Questions on Beals and Thomas Stormwater Report Peer Review dated 11/25/2024
Montrose School Campus Site Improvements
(John Woodhull, Conservation Commission, questions as discussed during meeting on 1/23/2025)

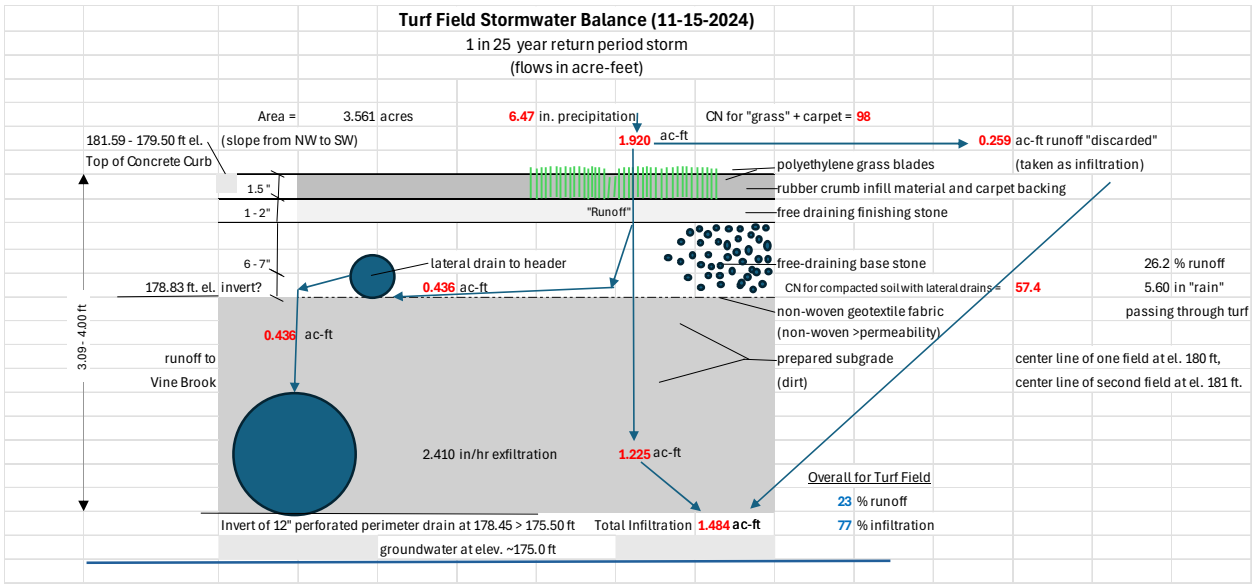
Infiltration to the subsurface beneath the turf field is not modeled using SCS curve numbers. It has been modeled as a "pond" using the Darcy Equation. Runoff rates do not "closely mimic an impervious surface" – runoff from the 1-in-100-year design case as modeled amounts to only 19% of incident rainfall. Runoff from an impervious service for a storm with the same recurrence interval is calculated as 97% using SCS with CN=98.

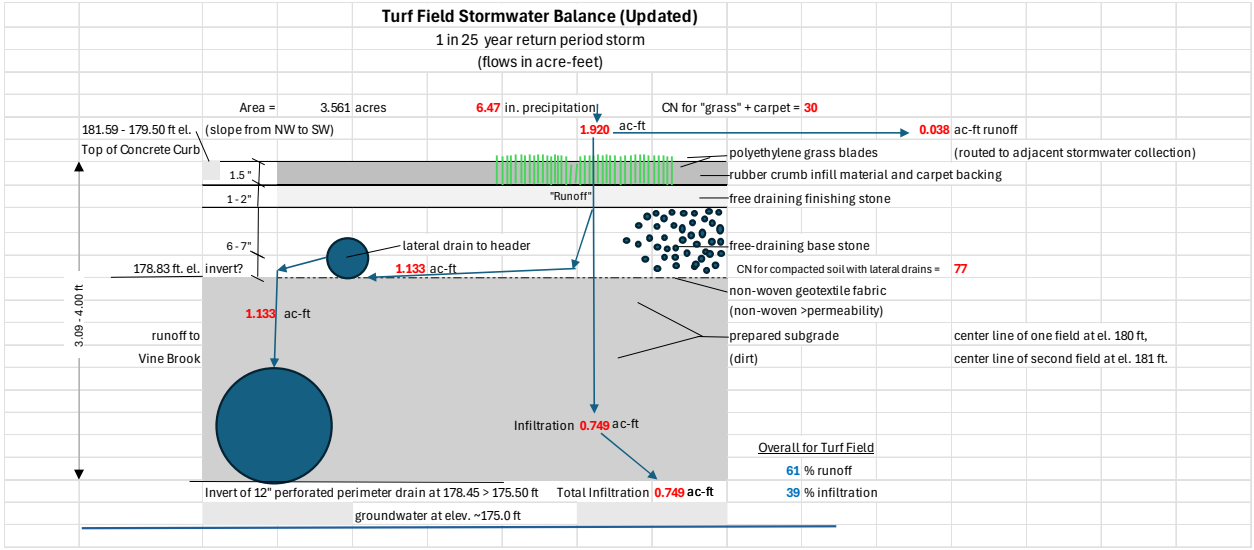
For calculation of the total volumetric flows or runoff and infiltration, the Turf Field Pond PS3 calculation block receives the "runoff" flow from sub-catchment P2E as an input and splits it between "primary" (runoff flow directed to Vine Brook reach R2 via the lateral drains and collection header) and "discarded", exfiltration from the storage volume (infiltration to the soil beneath "Pond" PS3) which is "discarded" from the model. As an illustration, the overall balance for the 1 in 25-year return period 24-hour storm using values from the calculations in the 11-15-2024 submittal from the Applicant is shown in the figure below:

To calculate what fraction of the "runoff" stream flows through the lateral drains to the drain header and ultimately to Vine Brook, the curve number calculation method is not used; instead, the geotextile fabric/soil surface has been modeled using the Darcy equation and a saturated hydraulic conductivity (K_{sat}) of 2.410 inches per hour. The Darcy equation calculates infiltration flux as the product of the hydraulic conductivity and the hydraulic gradient. The assumptions that have been used to define the hydraulic gradient are very important to the result, but are not clear from the HydroCAD output. For the 1-in-25-year 24-hour storm event and the 11-15-2024 version of the HydroCAD model, the result is a runoff volume equivalent to what would be obtained using a CN of about 52 – much lower than the runoff volume B&T anticipated when commenting that the CN value for the synthetic turf field should be set at 98.

The response from Beals and Thomas to the updated stormwater calculations described above is: "**This comment has been addressed by the applicant.**"
